STATE OF WASHINGTON
DEPARTMENT OF ECOLOGY

Re: Washington State Department of Ecology's (Ecology) Determination that the Focused Feasibility Study for the Former GE Facility (220 South Dawson Street) is Ready for Public Comment

Re: Ecology Comments on the Draft Revised Focused Feasibility Study (FFS) Report, dated
October 17, 2008

FIGURE 1-1

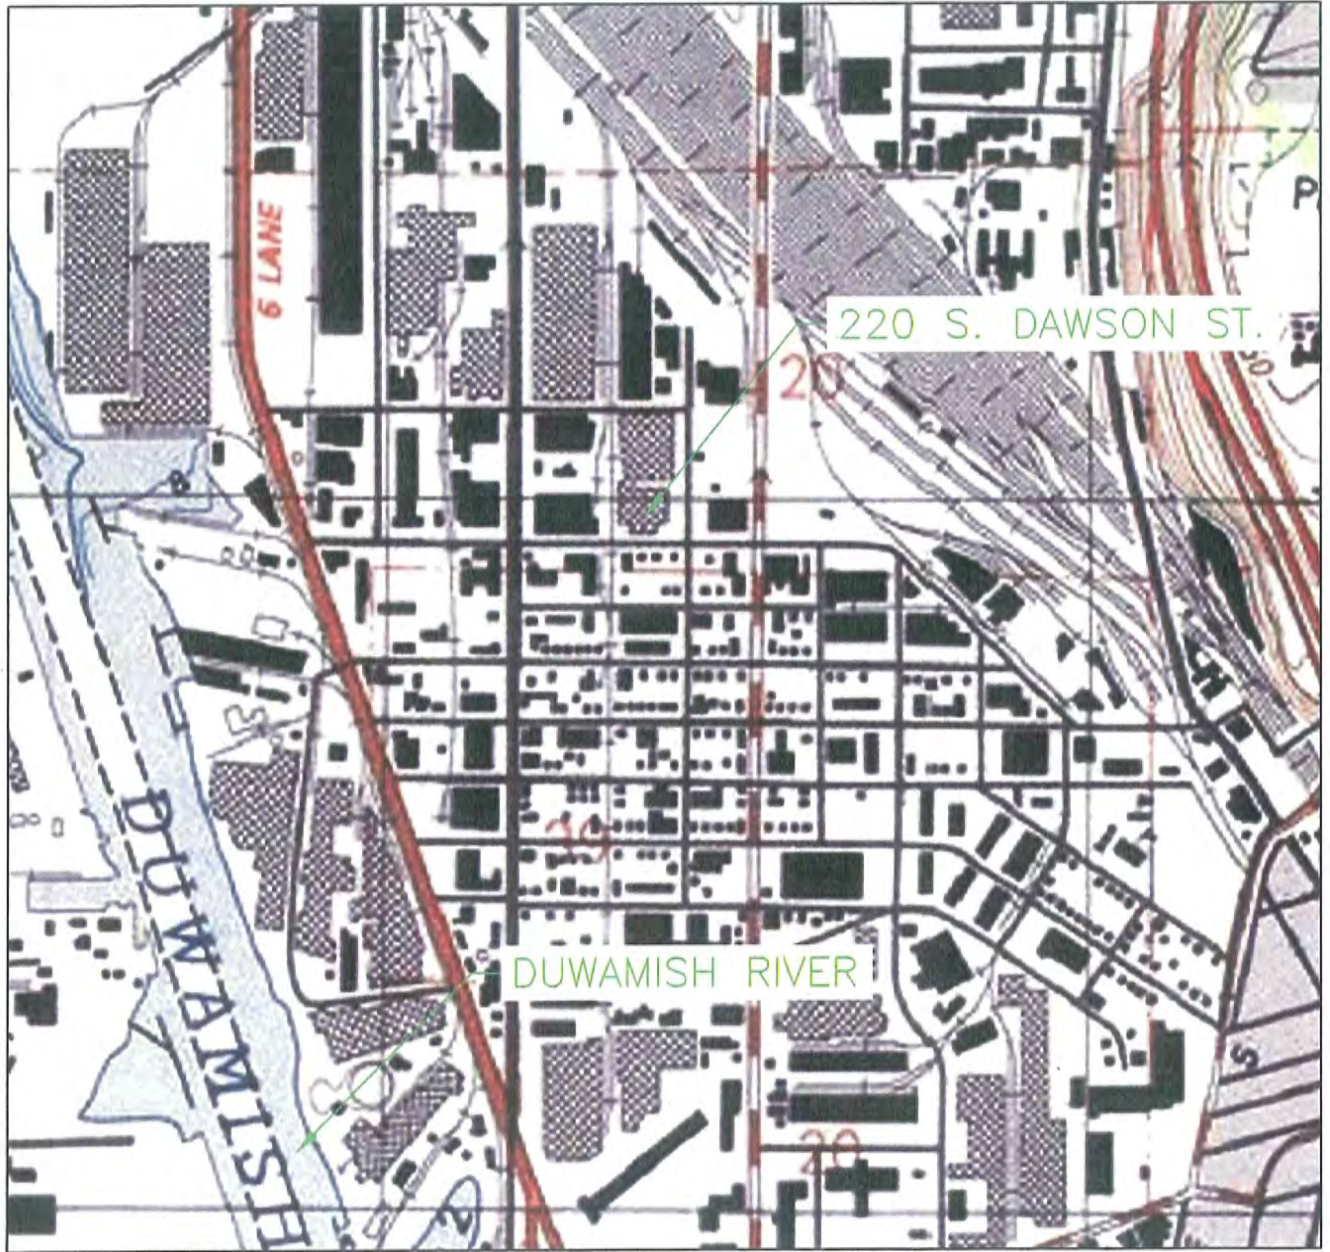
2. GE should include a figure showing the facility (including onsite and offsite monitoring wells) and its proximity to the Duwamish River and Slip 1. This figure is important for visually understanding the site conceptual model in this Section and Section 3.0, where cleanup levels are discussed.	Accepted	Figure 1-1 - Site Vicinity Map was added. The view includes Slip 1 and the Duwamish River.

GE - S. DAWSON STREET 02978-415-735		1994 CROSS SECTION TRICHLOROETHENE
DATE: 06/06/08	DRWN: E.M./SEA	FIGURE 2-12

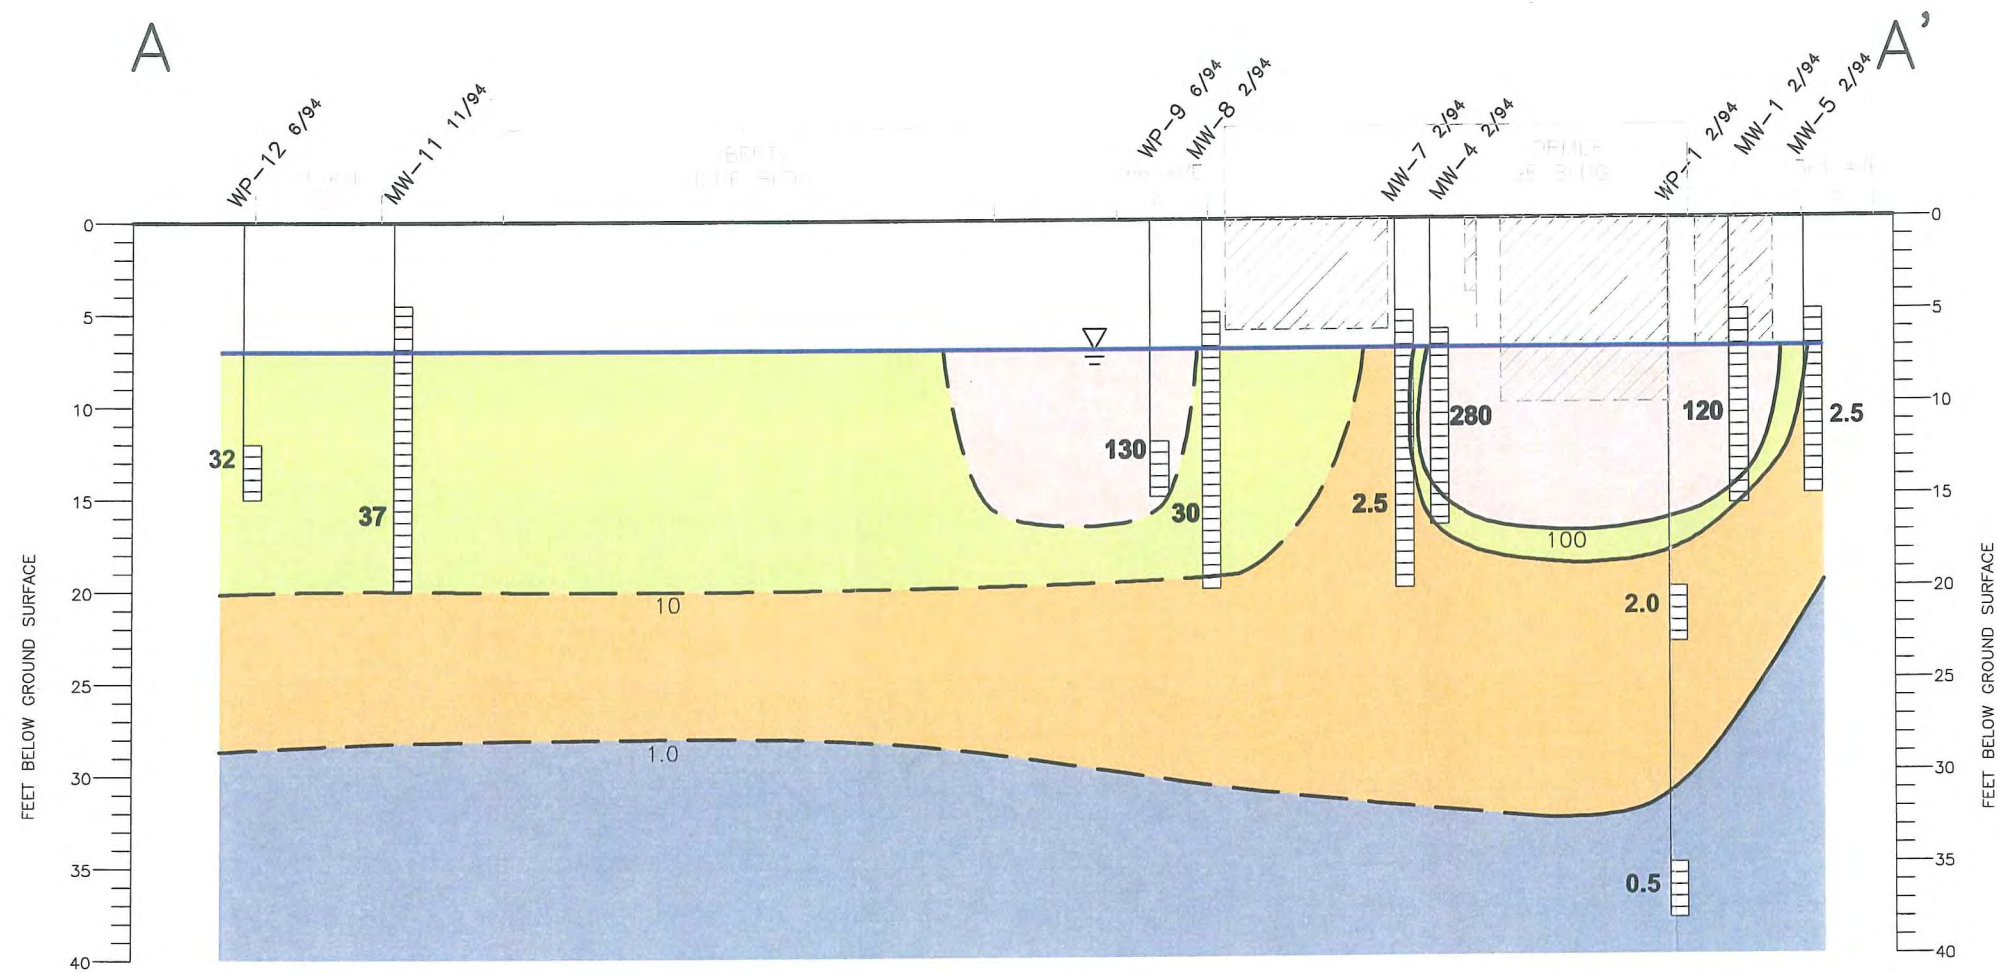
5. Figures 2-12 through 2-27: As stated previously in Ecology's August 14, 2008 response letter (Attachment B, comment 6), the concentration contour figures here were prepared by GE/ENSR based on their interpretation of the groundwater data. Ecology does not agree with this interpretation of the groundwater data or with the contouring approach used in these figures³. Ecology will expect the final remedy design in the Cleanup Action Plan (using Alternative 2 as modified by Ecology's Comment Letters) will reflect the assumption that the downgradient chlorinated volatile organic contaminants (CVOCs) groundwater plume is continuous. This point will be key to successful implementation of in-situ chemical oxidation (ISCO) at the site.

SUB-SLAB DEPRESSURIZATION SYSTEM
FIGURE 5-2

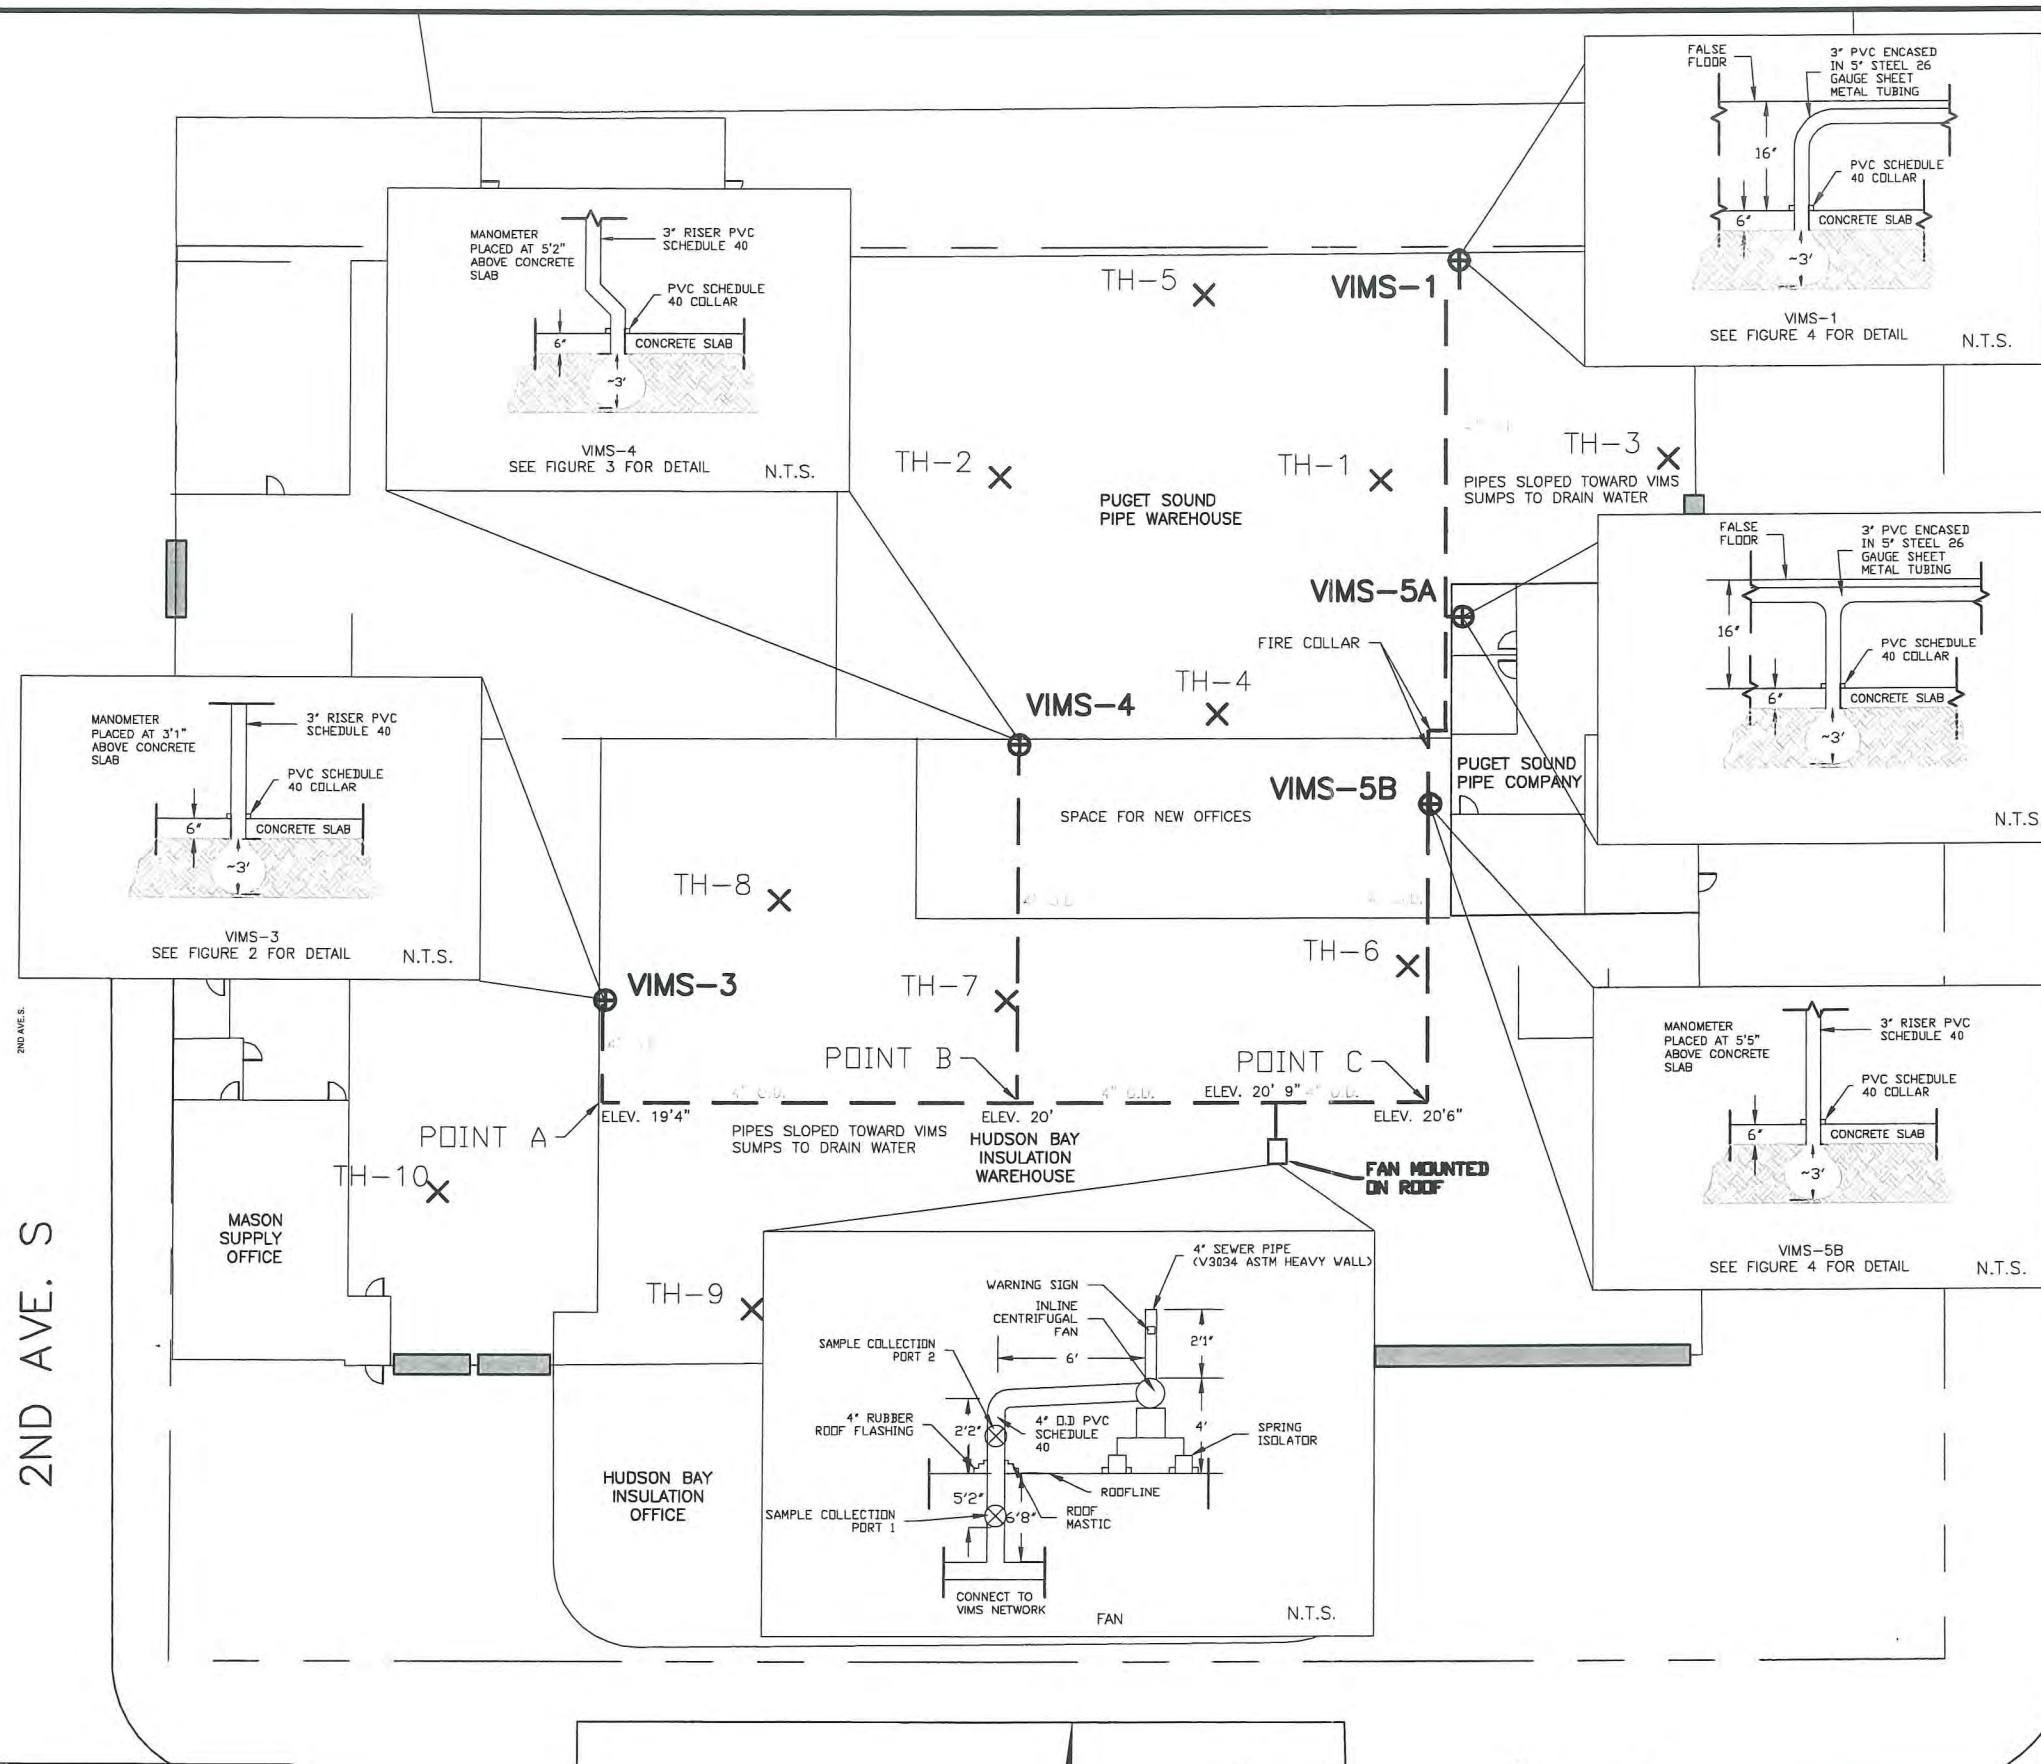
- d. Even though the modeling results presented to Ecology are insufficiently conservative and under-predict plume expansion, revised FFS Figures 2-36, 5-2, and Appendix C Figures 6, 7, and 16 all show TCE groundwater plume expansion resulting in increased

GE - S. DAWSON STREET 02978-415-735		ALTERNATIVE 2
DATE: 06/09/08	DRWN: E.M./SEA	FIGURE 5-3

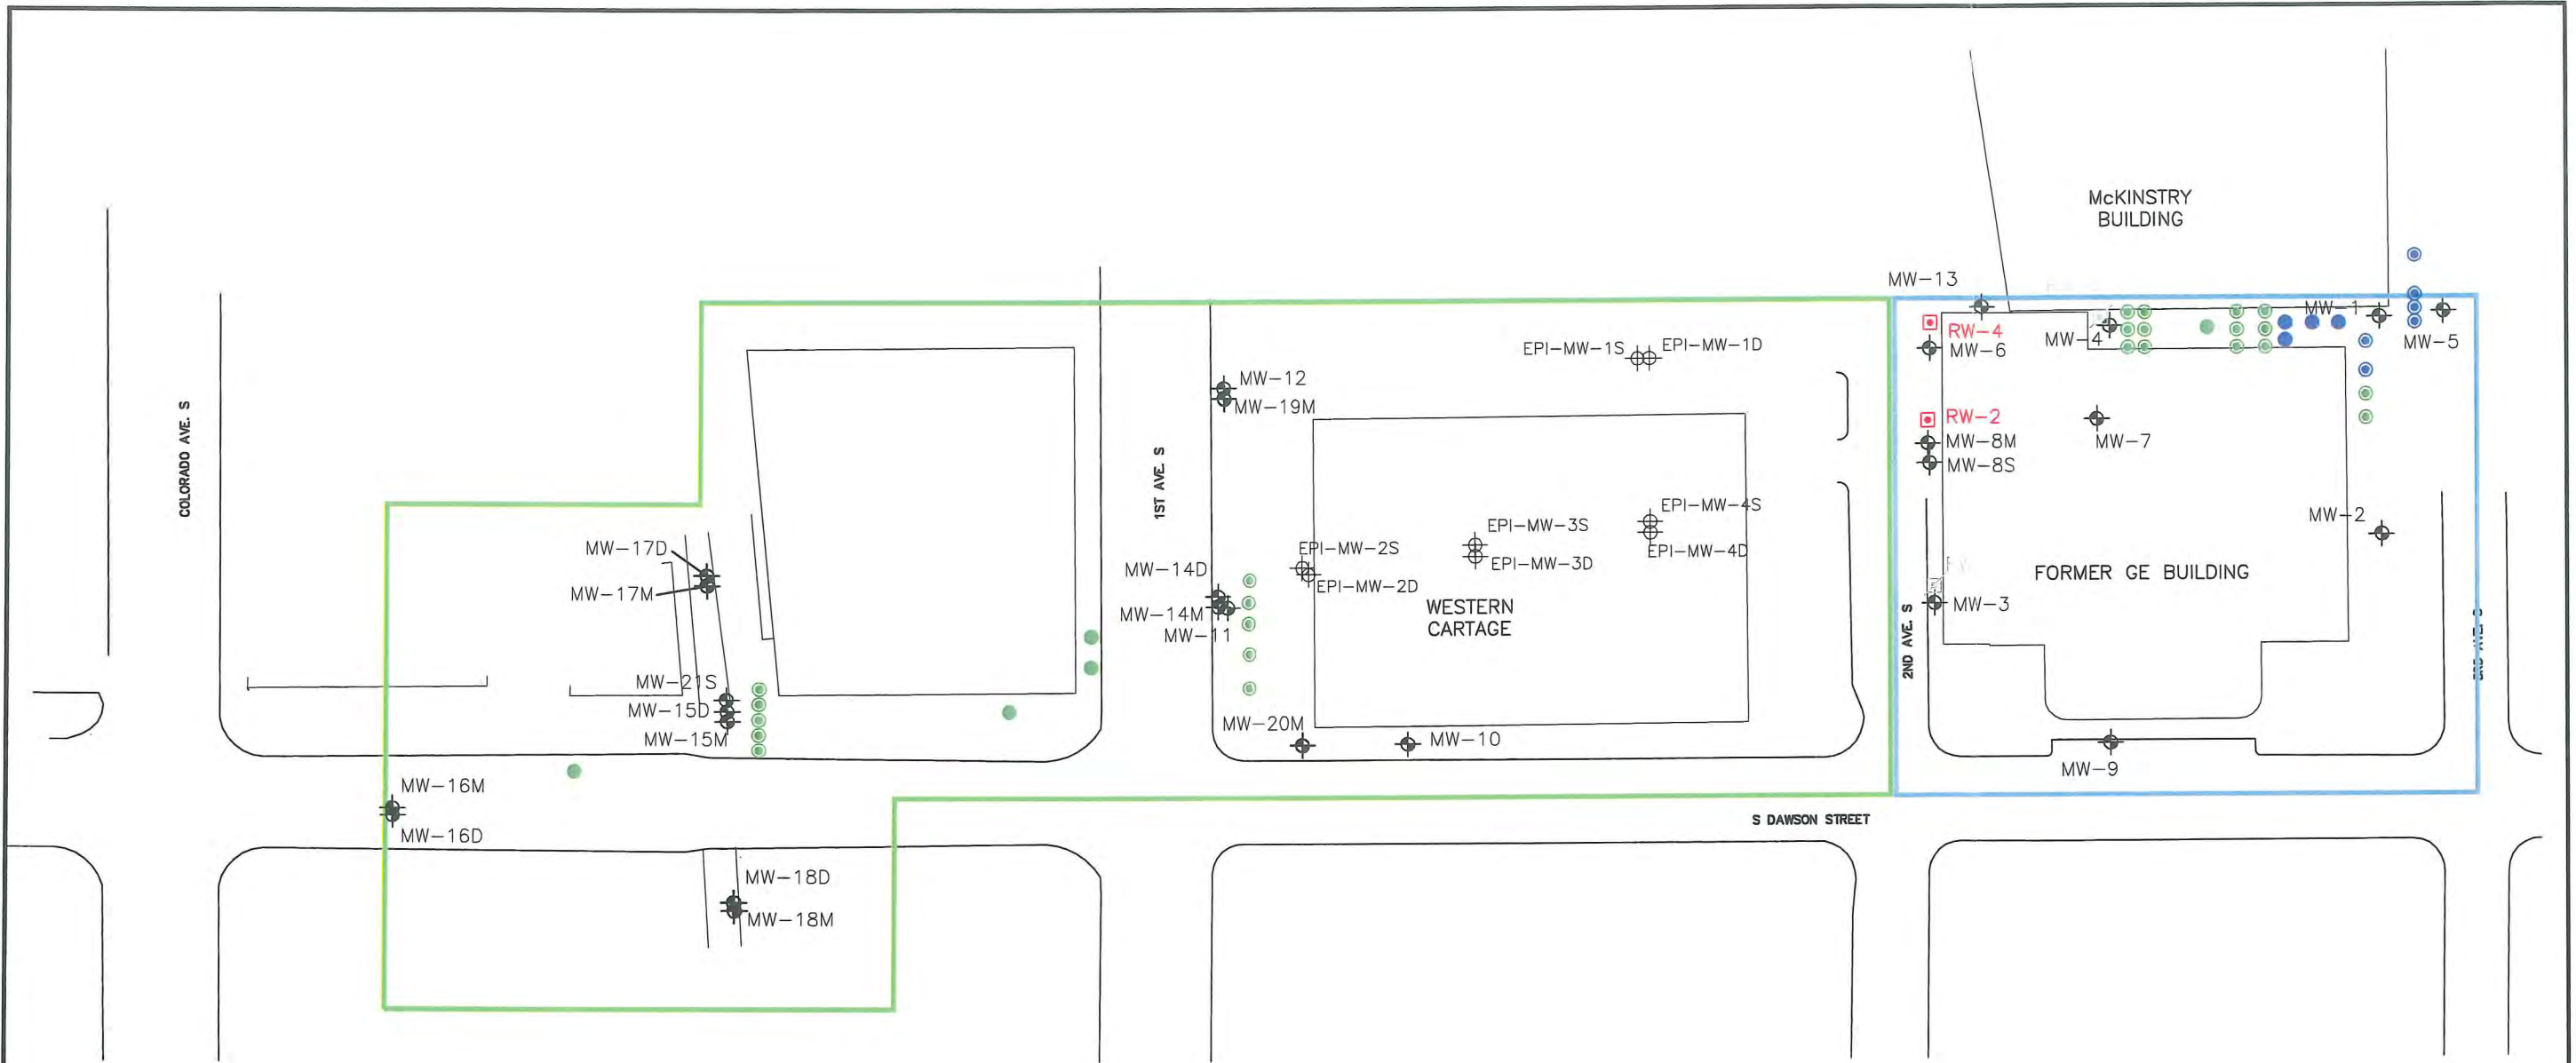
injections to the full depth of the off property plume, at 55 feet bgs. (Ecology notes that Figures 5-3 and 5-6 stated these deeper injections would occur). In addition, per Ecology's August 14, 2008 letter, GE did not, but needs to, revise these figures and the Section 5.3 text to include ISCO injections at 2nd Avenue South, upgradient of the Western Cartage building.

I.c.- Relocation of the groundwater extraction wells and pumping rates. As part of the hydraulic control optimization for alternative #7 alone, GE should analyze relocating both extraction wells, RW-2 and RW-3 to the east side of 2nd Avenue South.	Addressed	Section 5.3 updated to reflect Ecology's comments related to Alternative 2, Figure 5-3 was also updated.
I.d.- Offsite ISCO Injections. GE's proposed offsite injection points near MW-15D/M will not be deep enough to treat the CVOCs at the maximum known depth of 55' bgs. Since monitored natural attenuation is not proposed as part of the final remedy, the injection wells near MW-15D/M should therefore extend down to at least 55' bgs.	Addressed	Section 5.3 was updated to include an additional observation well set screened at the deeper portion of the aquifer is included in Alternatives 2 and 5 (under Phases 2 and 5). Figures 5-3 and 5-6 were updated.
